**BEFORE INDEPENDENT HEARING COMMISSIONERS
IN CHRISTCHURCH**

IN THE MATTER of the hearing of submissions on Private Plan Change 23
Whisper Creek, Spencerville to the Christchurch District Plan

**STATEMENT OF PRIMARY EVIDENCE OF DAVID JOHN ROBERT SMITH ON
BEHALF OF CHRISTCHURCH CITY COUNCIL**

Figure 1 Specific Purpose (Golf Resort) Whisper Creek ODP²

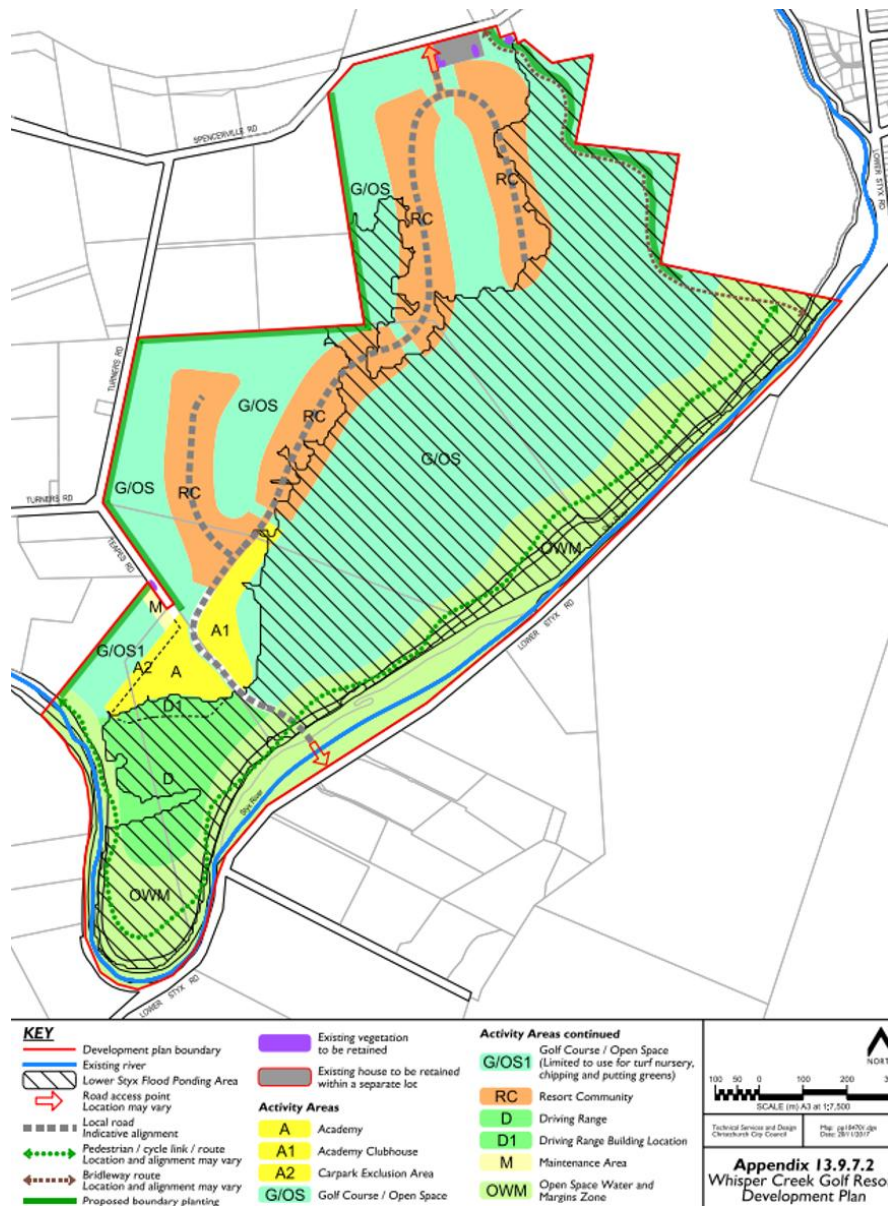
21. The current Outline Development Plan under the Specific Purpose (Golf Resort) zoning includes road accesses to Lower Styx Road and Spencerville Road and the Service Vehicle only access to Teapes Road. The existing ODP for the site is shown in Figure 1.

Figure 2 Plan Change 23 ODP³

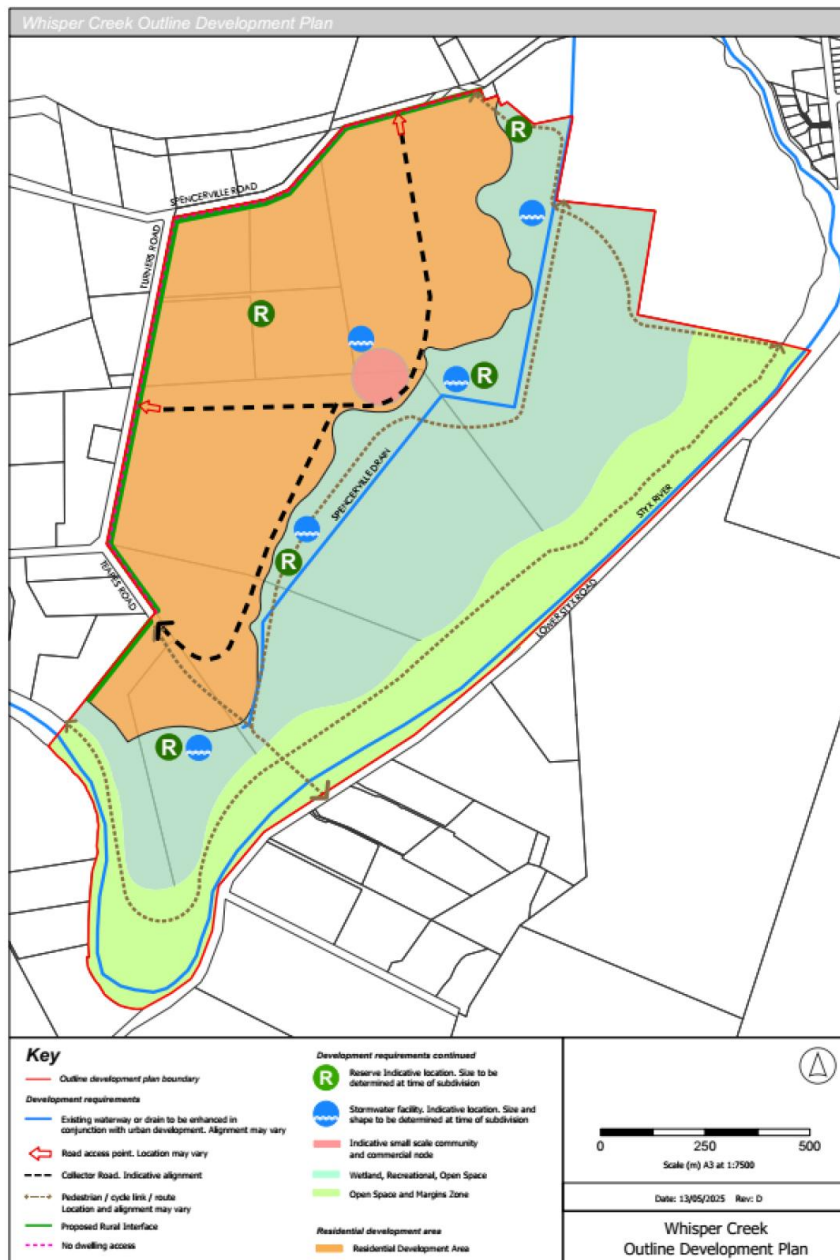
22. The proposed PPC23 ODP (refer Figure 2) proposes vehicle connections to Spencerville Road, Turners Road and the end of Teapes Road, but proposes to only provide a walk/cycle connection at the existing bridge across the Styx River to Lower Styx Road.

25. There is a lack of assessment of the merits of a direct connection onto Lower Styx Road (as signalled in the current Special Purpose zone ODP in Figure 1). In my view a direct connection would have the potential to reduce traffic volumes on Turners Road including in the vicinity of Ōuruhia Model School. However I note that a new intersection on Lower Styx Road (which is a higher speed 80 kph environment compared to Turners and Marshland Road and therefore may be less safe) would be required. It is recommended that further assessment be undertaken in relation to the merits of retaining this direct connection for general traffic.

Figure 3 PPC23 site with walk and cycle connections to school (blue arrow is proposed and red arrow is recommended)⁵

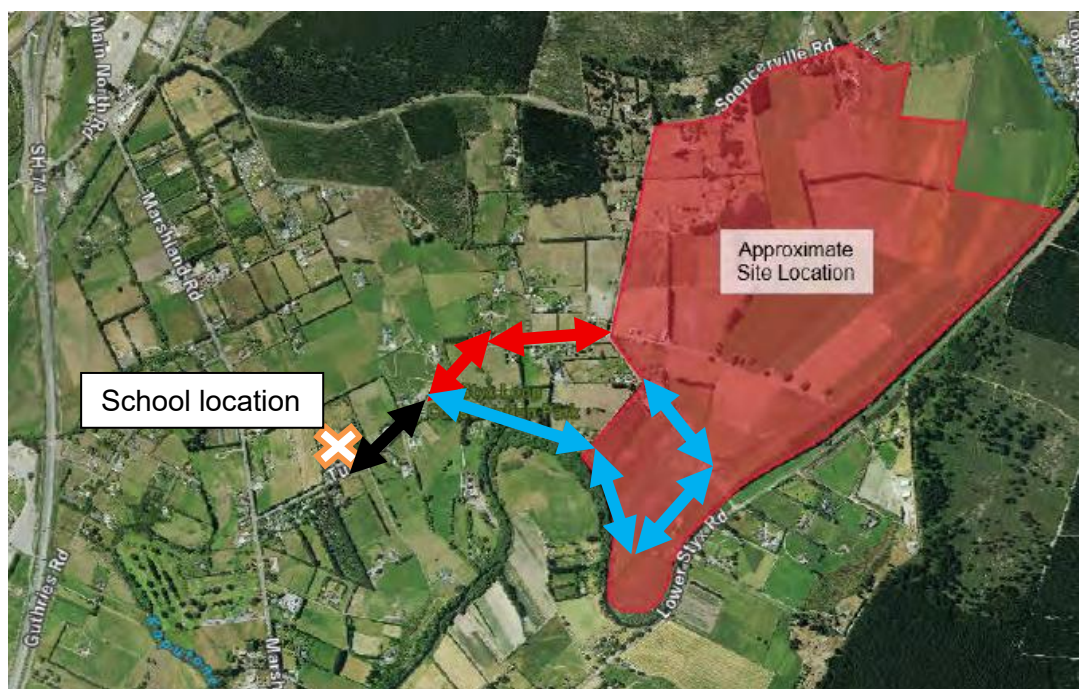
- (b) Whilst the construction of a shared path to the school is supported, it is noted that residents in the Plan Change area would need to walk or cycle to the southwest corner of the urban area, and then loop around the local recreational track down to the Styx River and back to access the Shared Path (shown by the blue arrows on Figure 3). This is not a direct and convenient connection in my view. Instead, I recommend that a shared path be formed along the length of Turners Road between the school and the Turners/Teapes intersection. This could replace the proposed (blue arrows) connection and in doing so provides a safe and direct connection as shown by the red arrow in Figure 3. The black arrow shows the portion of shared path along Turners Road as proposed - I recommend the school should be

accessed via the red and black route rather than the less direct blue and black route proposed in the application.

Figure 7 Property boundary visibility risk (source: ITA Appendix 3)

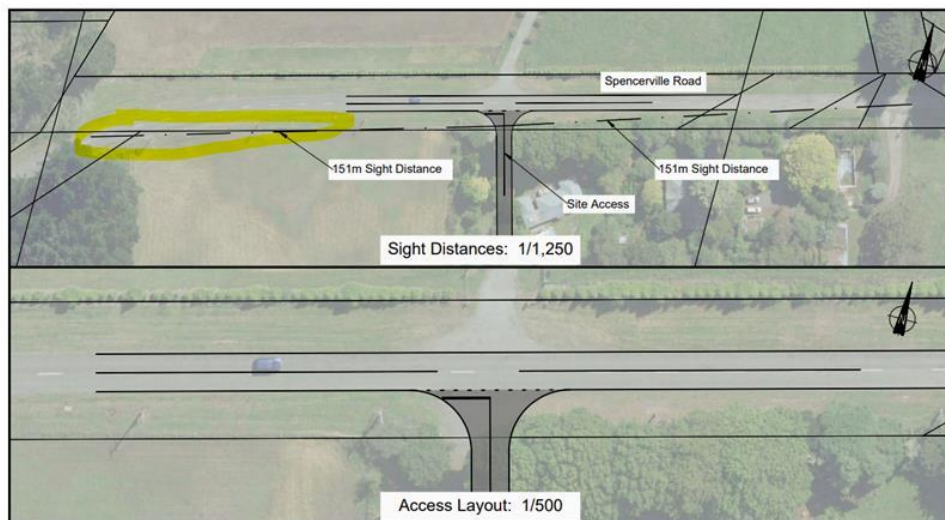
79. A submission received from the neighbouring property directly opposite the Spencerville Road access raises concerns about visibility at this location. I have reviewed the assessment provided in the ITA report and note these have been designed to achieve the minimum 151m sight distance which based on industry guidance¹² is suitable at a 70km/h design speed (where the design speed is 10km/h faster than posted speed).
80. The visibility to the west could be impeded by future fences or vegetation along the Plan Change site boundary (see highlighted yellow section on Figure 7). It is recommended that a small section of the property be vested as road reserve to maintain the minimum sight distance.
